Delegated officer report for planning application

Application no. 132511/NMC/2021

Proposal: Non-material amendment application to planning approval reference 129109/JO/2021 to allow elevational alterations, removal of concierge drop off point and canopy and Change in angle of PV cells on roof top

1 GA North Elevation
Approved Planning Drawing 2020 - North Elevation

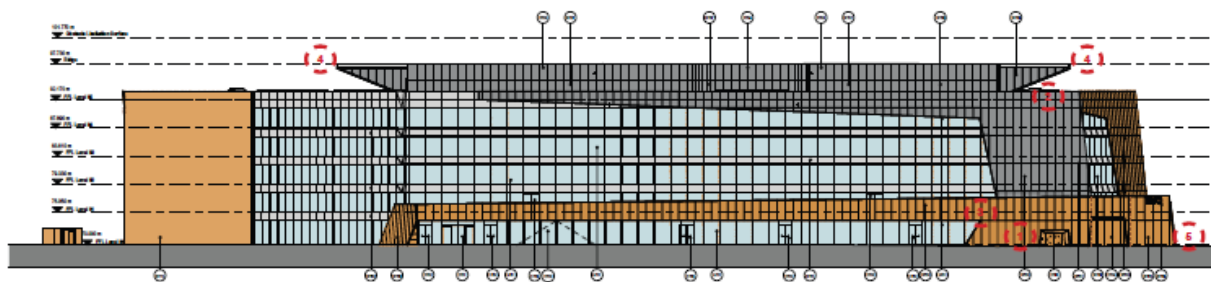
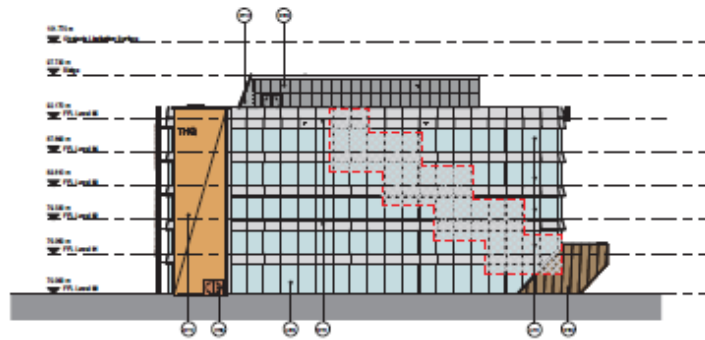
North Elevation

- Removal of concierge drop off point and canopy;
- Change escape door to recessed type;
- Re-profile of parapet behind mesh to head of escape stair;
- Change in angle of PV cells.

1. Escape door configuration updated
2. Change to parapet behind mesh cladding
3. Removal of concierge drop off point and canopy
4. PV angle change
5. HV transformer room doors omitted

Approved Planning Drawing 2020 - East Elevation

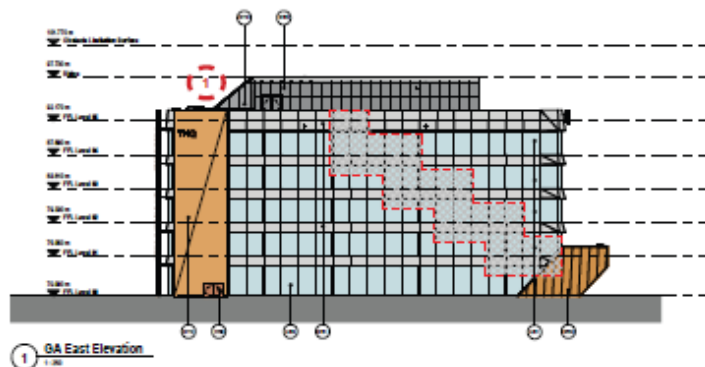
- Removal of concierge drop off point and canopy;
- HV transformer room doors omitted;
- Re-profile of parapet behind mesh to head of escape door;
- Change in angle of PV cells.

1. PV angle change

Approved Drawing 2020 - South Elevation

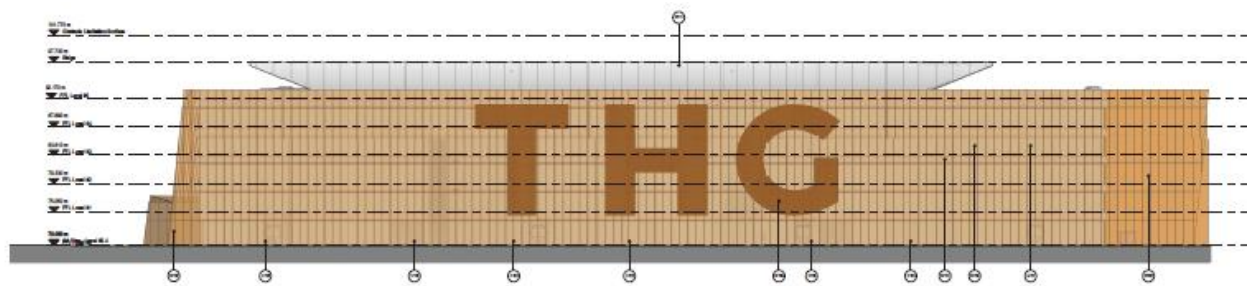
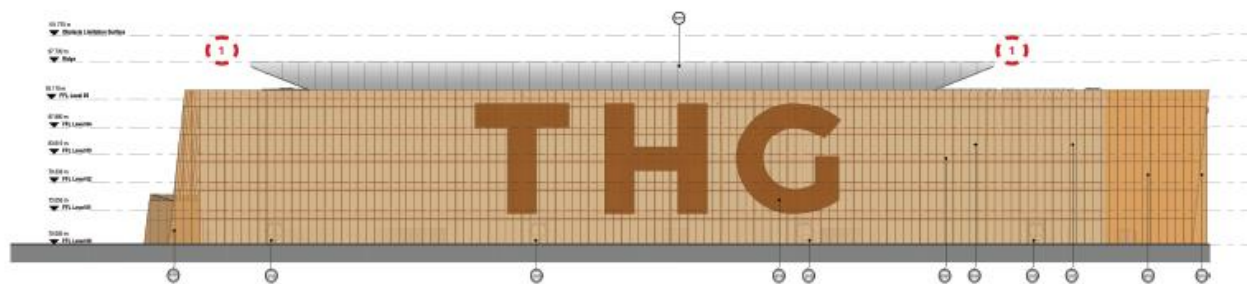
South Elevation
- Change in angle of PV cells.

1. PV angle change
